NBSIR 83-2693

Development of Draft Construction Safety Standards for Excavations

Volume II

April 1983

Figure 4. Components of the Shoring System

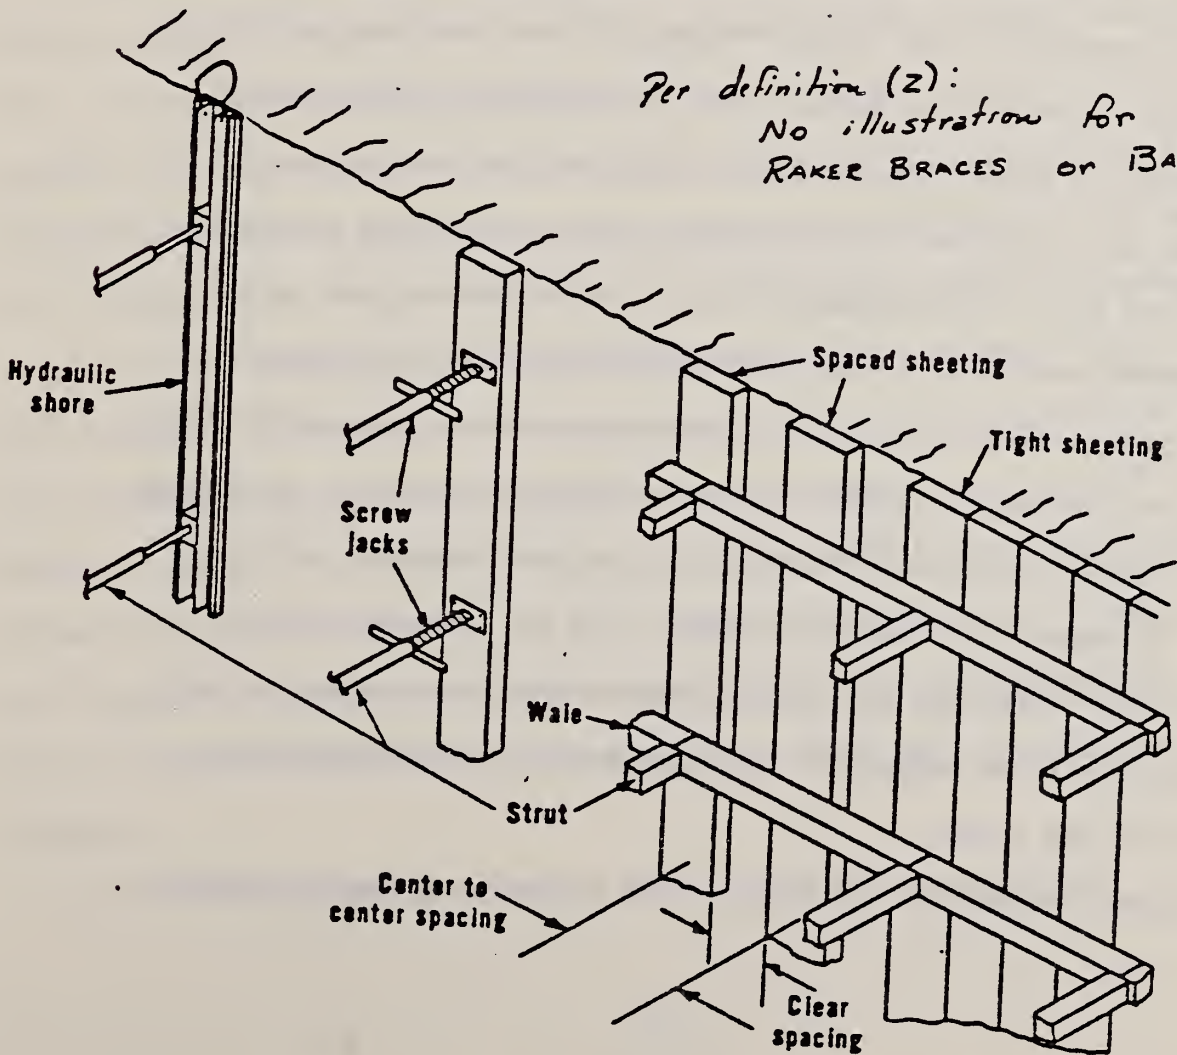
- ✓ (w) Spaced Sheeting is sheeting in which the members bearing against the excavation wall are spaced (see Figure 6). *Figure 4?*
- ✓ (x) Spalling is the continuous flaking and falling of soil or rock from an unsupported trench wall.

- ✓ (y) Standard Practice is the trenching and shoring practice in Section 1926.652 (b).
- ✓ (z) Struts are the primary support members of a shoring system including but not limited to cross braces, raker braces, jacks and backties (see Figure 6) *Figure 4?*

Raker braces or backties are not illustrated
